## PLANNING DIVISION STAFF REPORT

**Project Name & Address:** 911-915 Jenifer Street

**Application Type(s):** Certificate of Appropriateness for exterior alterations in the Third Lake Ridge Historic District

**Requested Action:** The Applicant is requesting that the Landmarks Commission approve a Certificate of Appropriateness for the replacement of a porch railing.

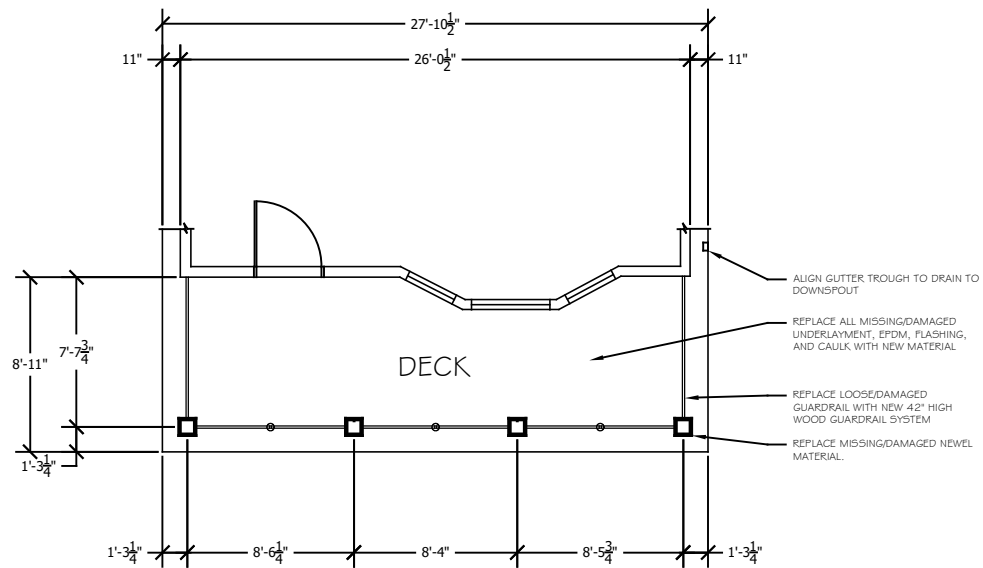
In accordance with the provisions of the Historic Preservation Ordinance, I have reviewed your plans for alterations at 915 Jenifer Street, located within the Third Lake Ridge Historic District, and am able to provide administrative approval to complete the work as described in your plans.

Please note that any scope of work or design changes from the alterations approved herein must receive approval by the Landmarks Commission, or staff designee, prior to commencing with the work. This Certificate is valid for 24 months from the date of issuance.
